**Responses to Questions Regarding the Highway 96 Dump Superfund Site
From the April 2009 North Oaks City Council Meeting**

**Prepared by Wenck Associates
May 12, 2009**

Chart 1 - Hwy 96 Dump Site, Residential Well Data (2004-2008), West Gilfillan Lake

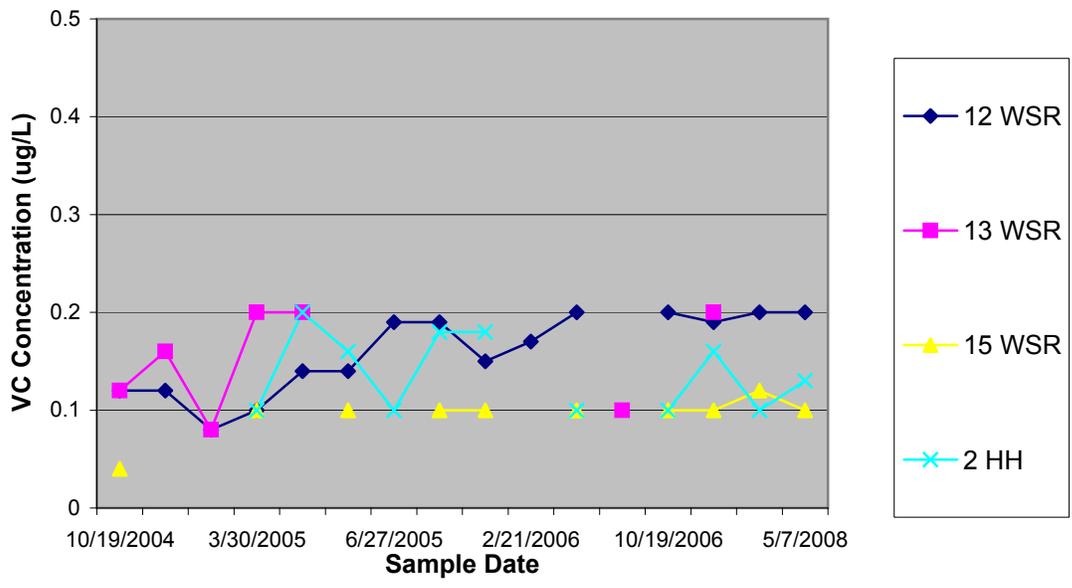
6. Jeff Apland, North Oaks resident, commented that the MPCA justifies the monitoring and remediation plans outlined in the MDD Amendment with the contention that, “After three and half years of intensified ground water monitoring by the Responsible Parties, there has been no indication of an increasing plume size or increasing vinyl chloride concentrations.” Mr. Apland presented a graph (Attachment 1) showing vinyl chloride data collected at 12 West Shore Road and asked, can the MPCA honestly say "there has been no indication of . . . increasing vinyl chloride concentrations?"

- 1. The graph only shows the data for one residential well (12 West Shore Rd), whereas the accompanying statement, taken from the Amendment to the Minnesota Decision Document was general in scope, and did not refer to one specific monitoring or residential well.**

- 2. If the data for all four vinyl chloride-contaminated wells on the west side of Gilfillan Lake (12 West Shore Rd, 13 West Shore Rd, 15 West Shore Rd, 2 Hummingbird Hill) are plotted on a similar chart (Attachment 2), there is no apparent increase in vinyl chloride concentrations.**

- 3. The MPCA acknowledges that the vinyl chloride concentrations in the residential well at 12 West Shore Rd appear to trend upward (see chart 2 in Attachment 2). In contrast, the vinyl chloride concentrations in the residential well at 2 Hummingbird Hill appear to trend downward (see chart 2 in Attachment 2). Thus, these apparent trends for individual wells should not be considered in isolation. Rather, it is more important to consider not only the results for all four vinyl chloride-contaminated wells, but the results for all sampled residential- and monitoring wells.**

- 4. The graph presented by Mr. Apland includes data from two different laboratories [Interpoll and Minnesota Department of Health (MDH)]. These two laboratories used different reporting and detection limits, which could potentially make it more difficult to compare or combine data.**

Response: The MPCA staff reviewed the summary chart submitted by Mr. Apland, and provided the following comments:

In summary, the MPCA believes that the collective residential well data (October 2004 - August 2008) do not show increasing vinyl chloride concentrations within the plume on the west side of Gilfillan Lake. However, the MPCA acknowledges that small-scale vinyl chloride increases (e.g., 12 West Shore Rd) and decreases (e.g., 2 Hummingbird Hill) may be present in the individual well data.
